Work Order ID 128022

Item Name: Aft Crosstube, STD w/o Peg Steps (MKII)

DRAWING NO.
D119-796-241

TITLE
XTUBE ASSY (AW119 MKII AFT)

D119-796-241BND CROSSTUBE, AFT 9
BENDING AND DRILLING DETAIL

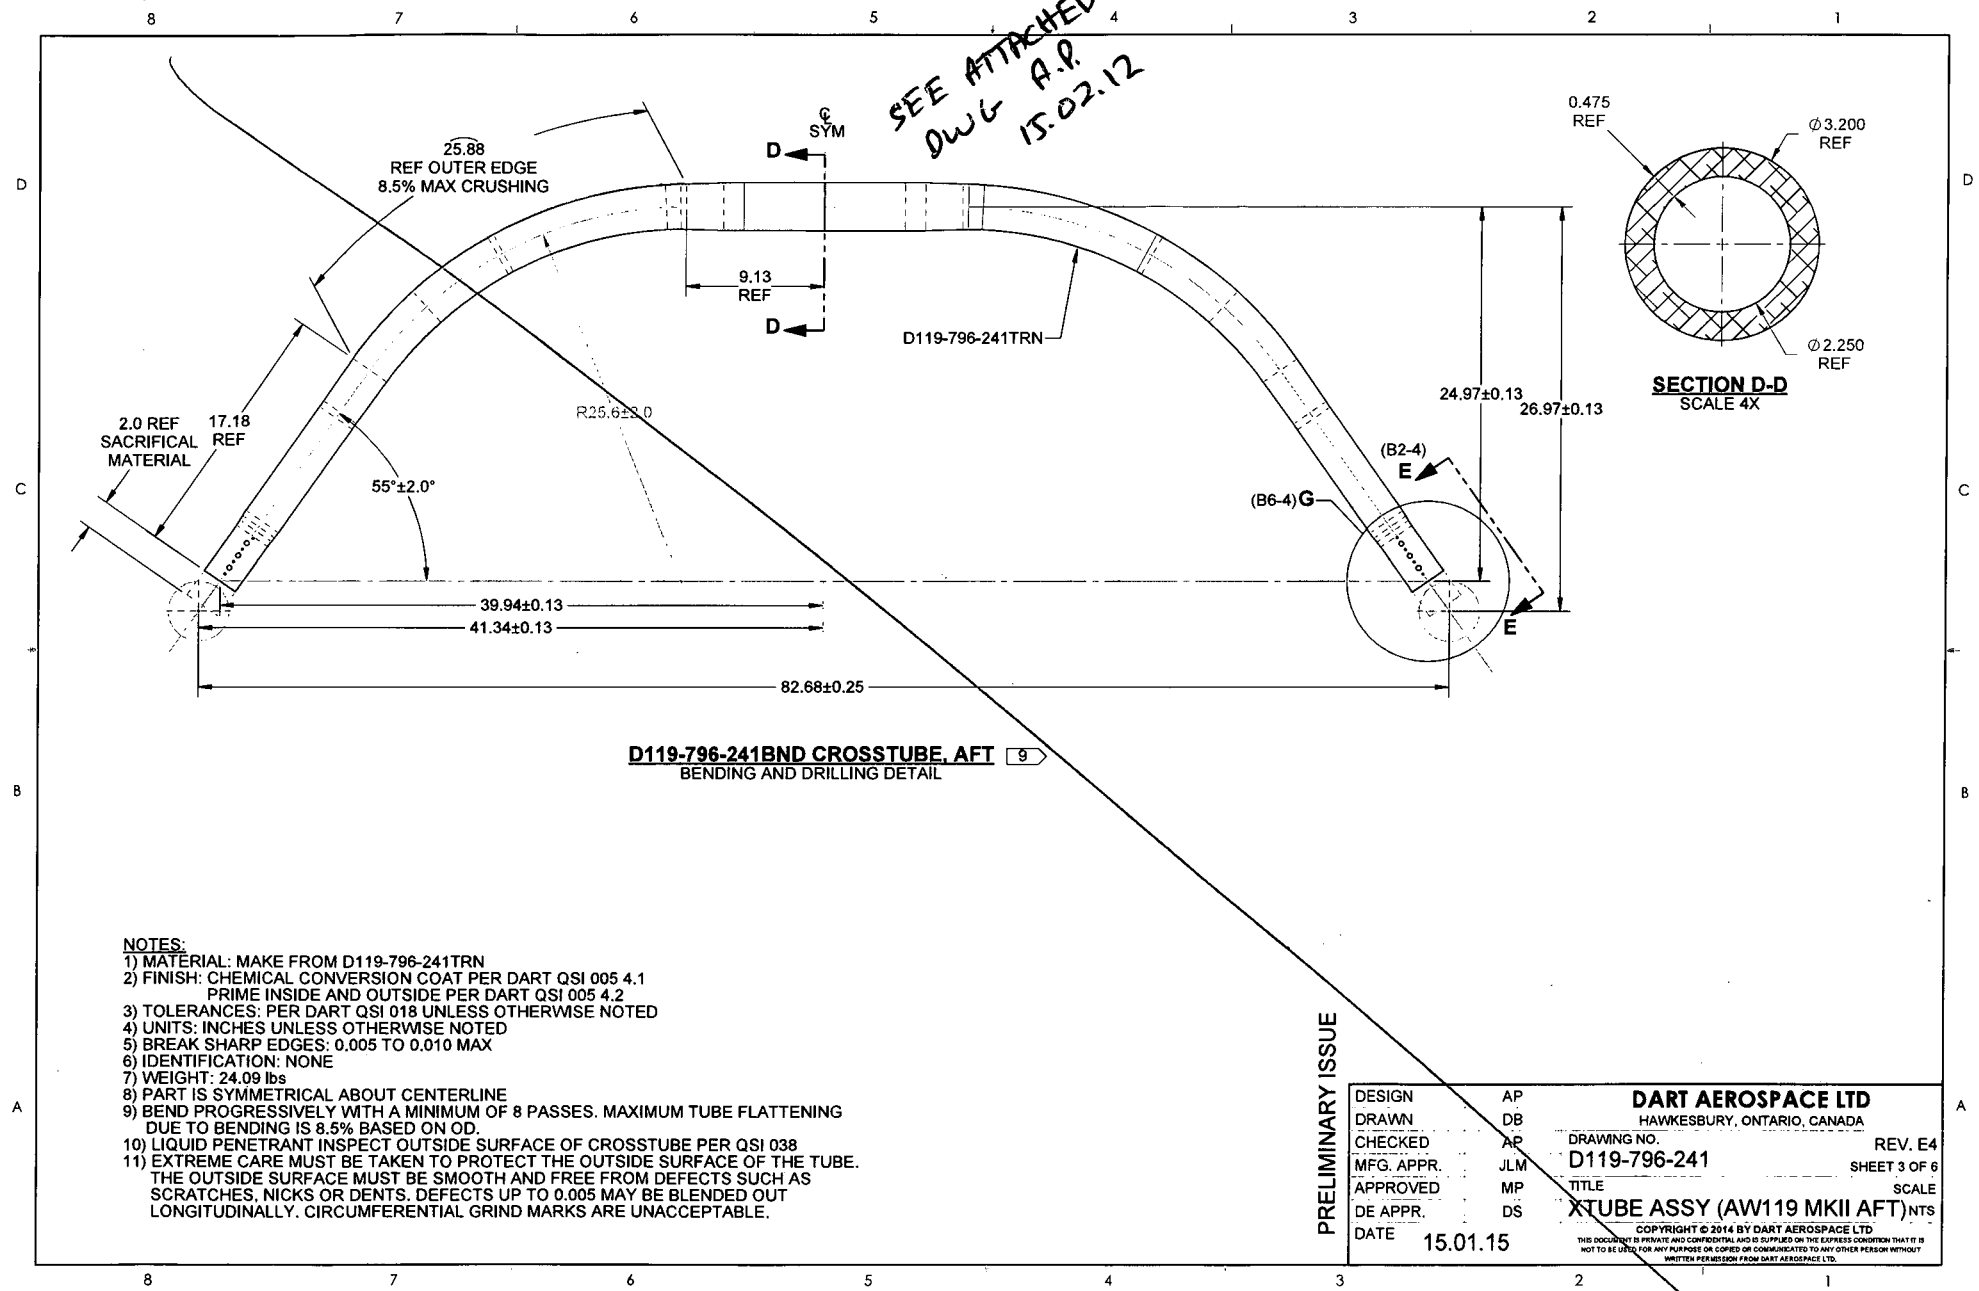
SEE ATTACHED
DWG A.P.
15.02.12

SEE ATTACHED
DWG A.P.
15.02.12

DETAIL G (C3-3)
SCALE 2X

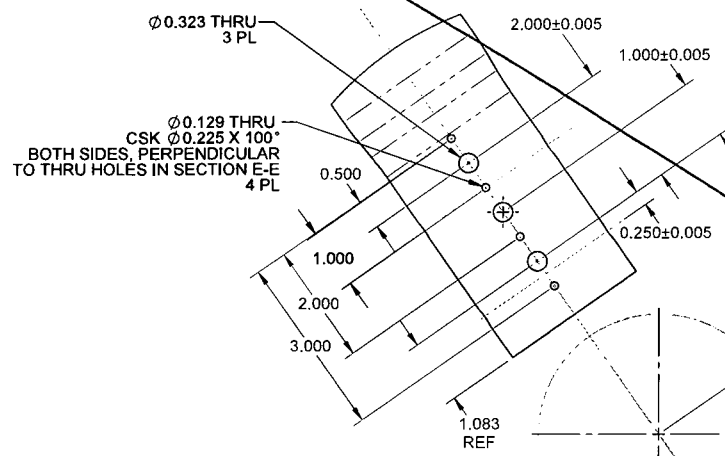
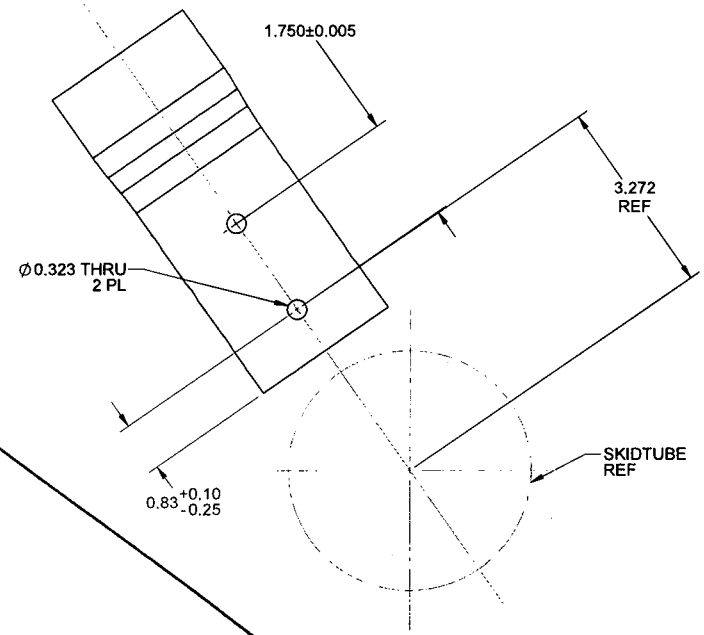
SEE ATTACHED
DWG A.P.
15.02.12

DETAIL H
SCALE 4X

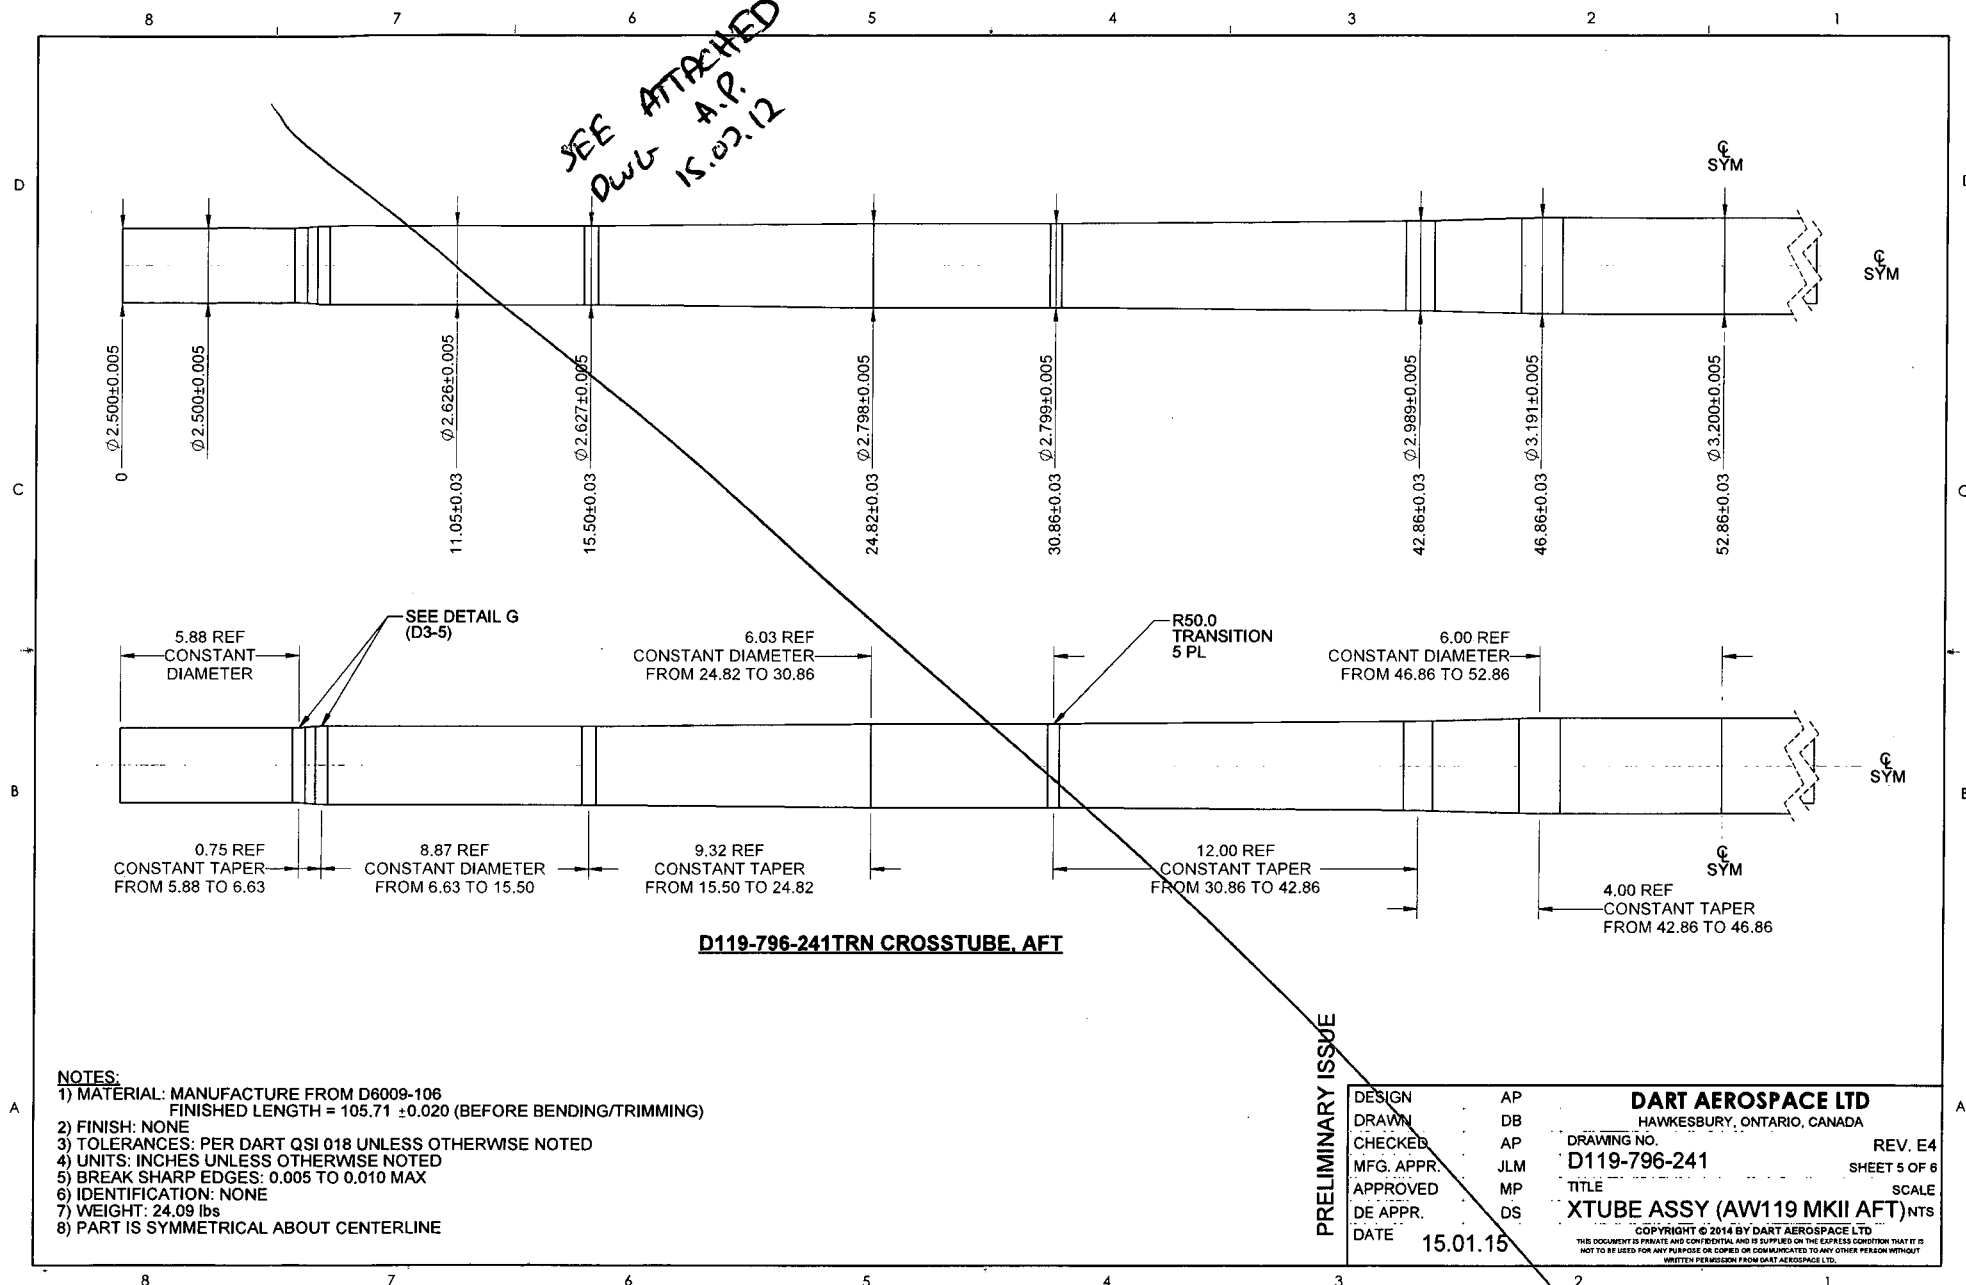
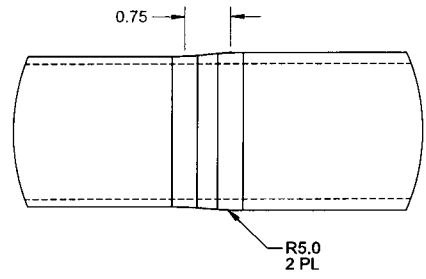
SEE ATTACHED
DWG A.P.
15.02.12

SEE ATTACHED
DWG- A.P.
15.02.12
